LiDAR Quality Assessment Report

Project ID:
ARRA Contract # W912EE-07-D-0005

Project Description:
MS Delta Yazoo Phase 1 2009-2010 LiDAR encompassing all of Tunica, Coahoma, Quitman, Tallahatchie, Leflore, Sunflower, Bolivar, Washington, Humphreys, Sharky and Issaquena Cos., and the western-central area of Warren, Yazoo, Holmes, Carroll, Grenada, Yalobusha, Panola, Tate and Desoto Cos. in Mississippi. Contract W912EE-07-D-0005

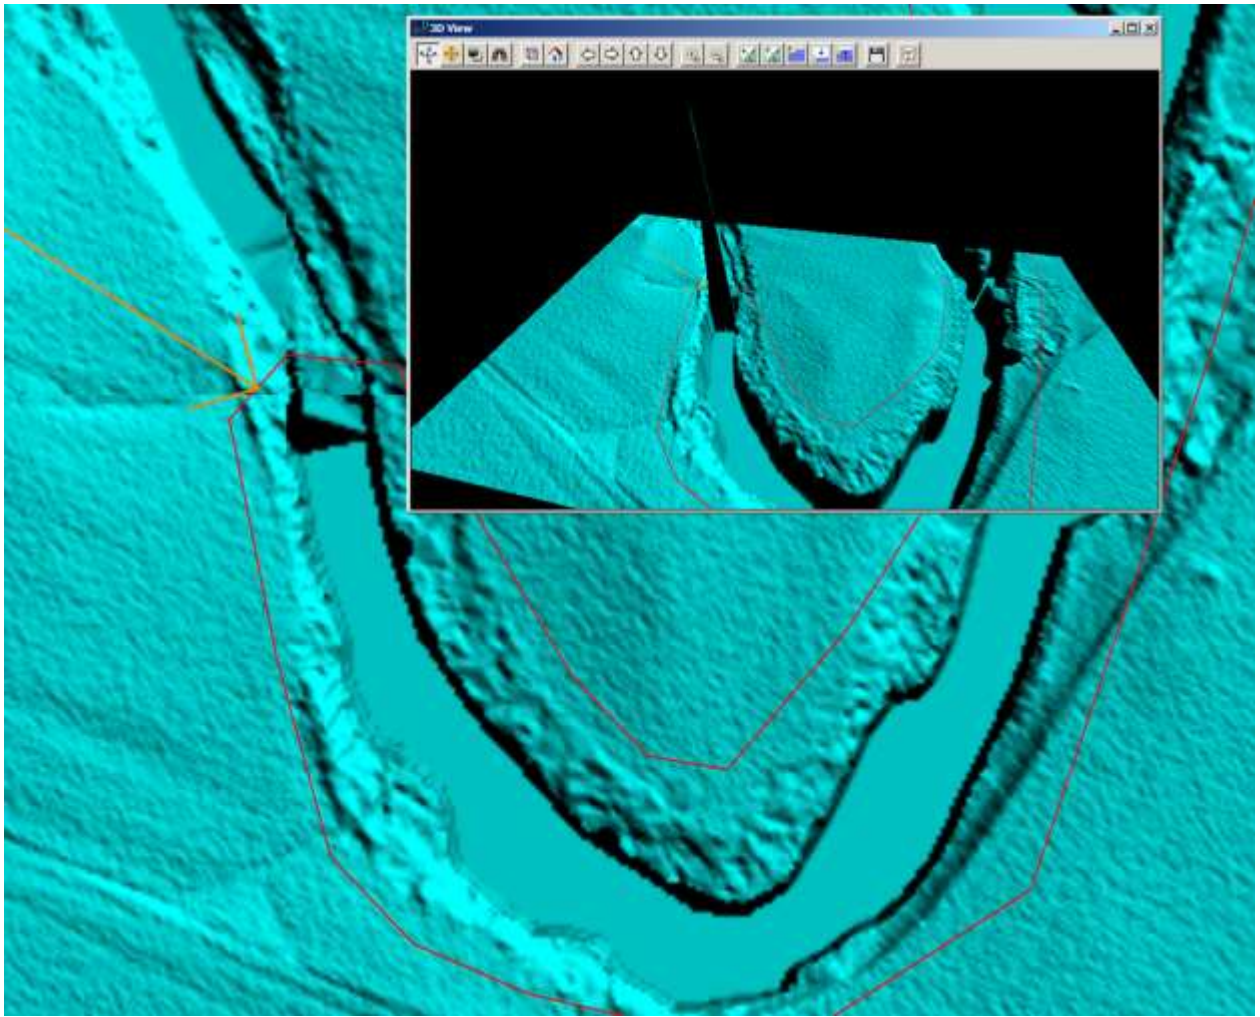
water body too deep & spike at seam line in 3 D

**Fixed by vendor.

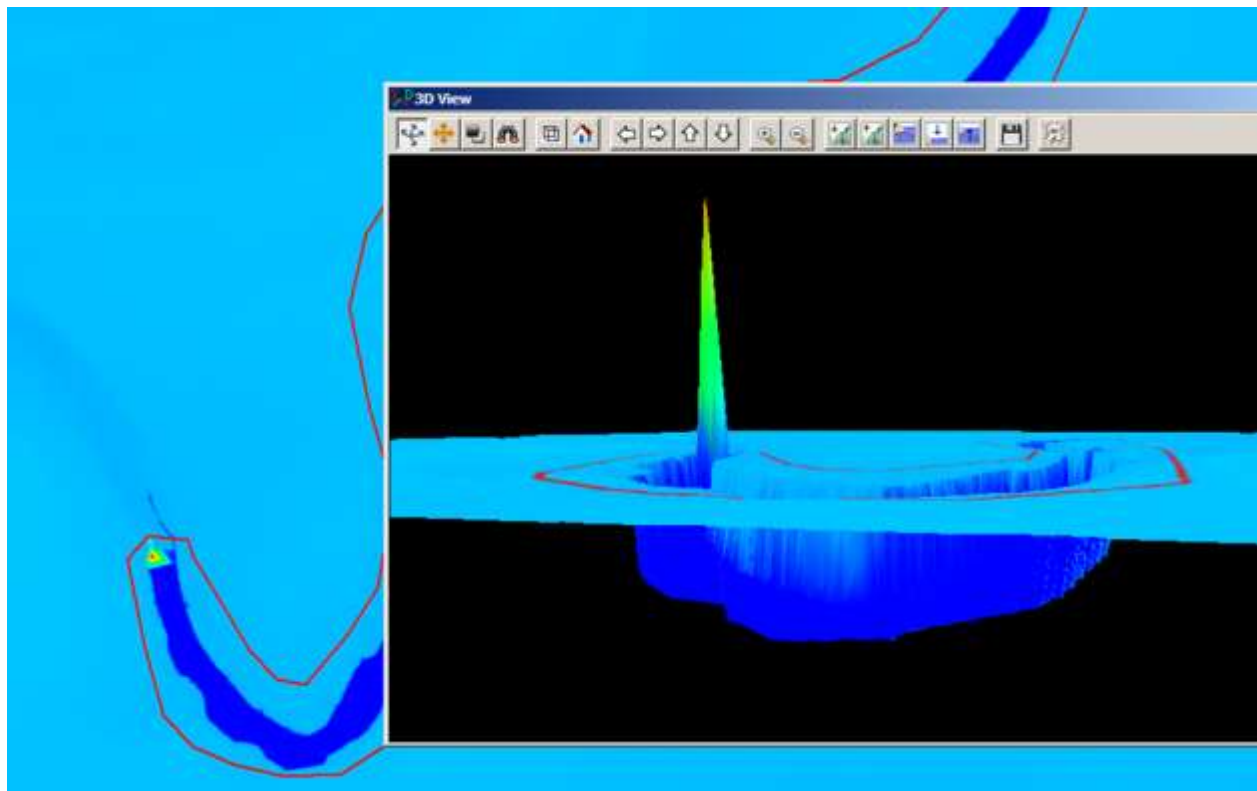
water body too deep & spike at seam line in 3 D

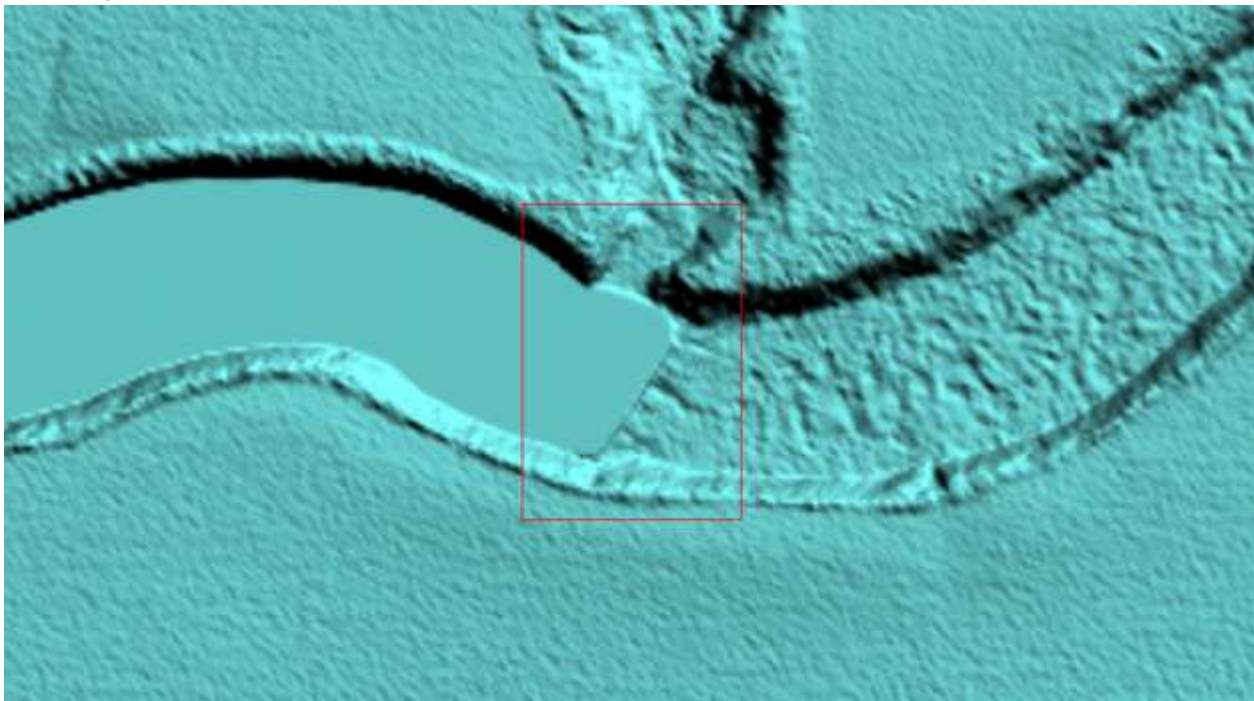
6/12/2012
Floating water - 34° 19' 19.8" N, 90° 21' 17" W.

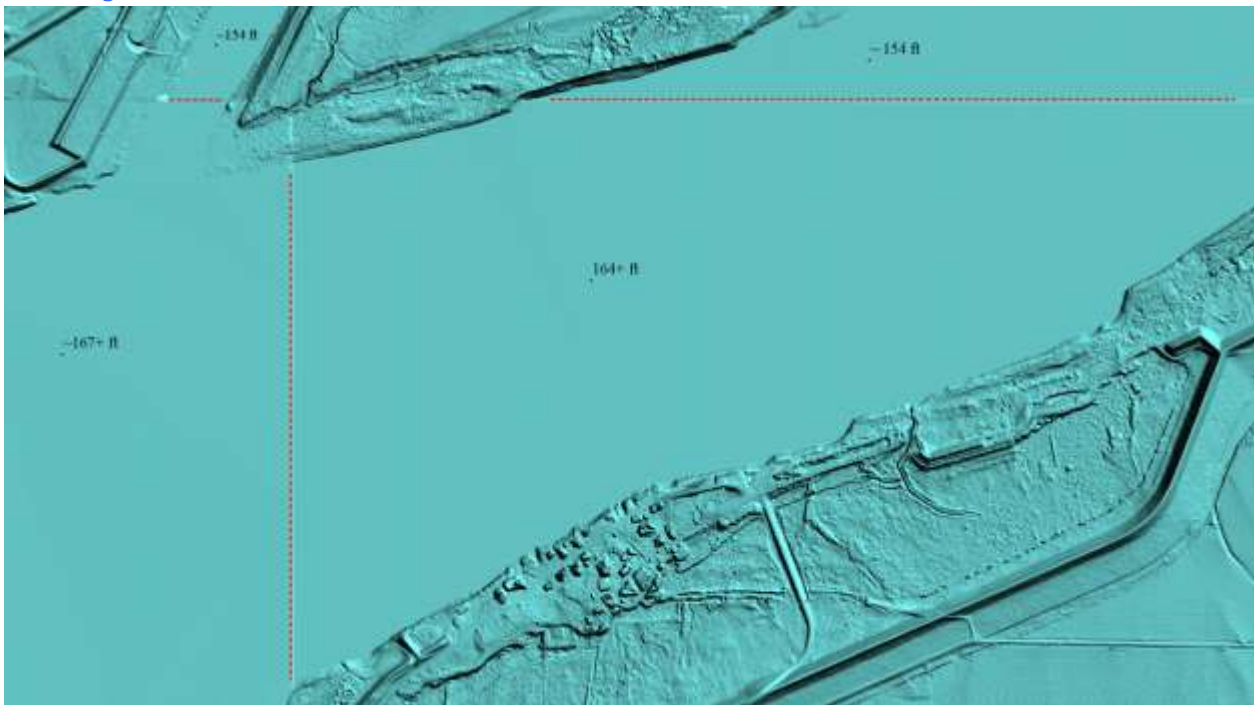
Multi_water_elevations - 34° 23' 18.5" N, 90° 37' 36" W

Stretches along this river consist of different elevations; these elevation changes are not gradual, but abrupt.

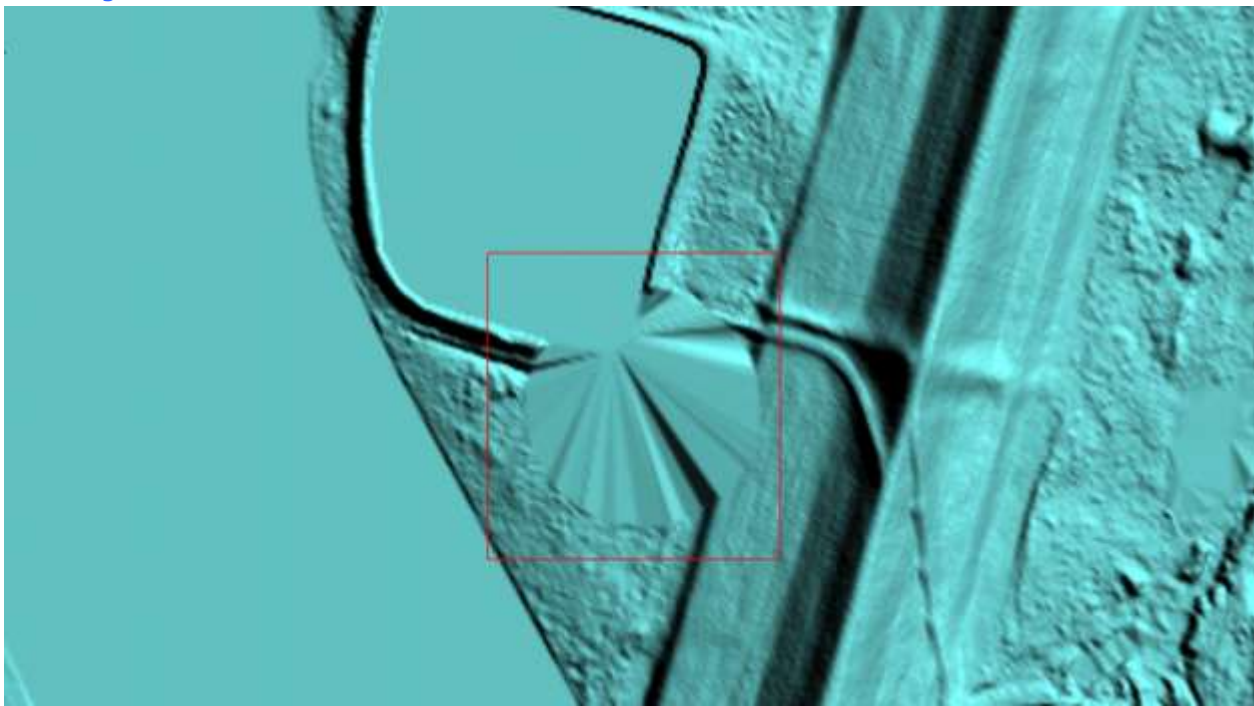
6/12/2012
Unknown - 32° 49' 23.6" N, 91° 10' 10.6" W.
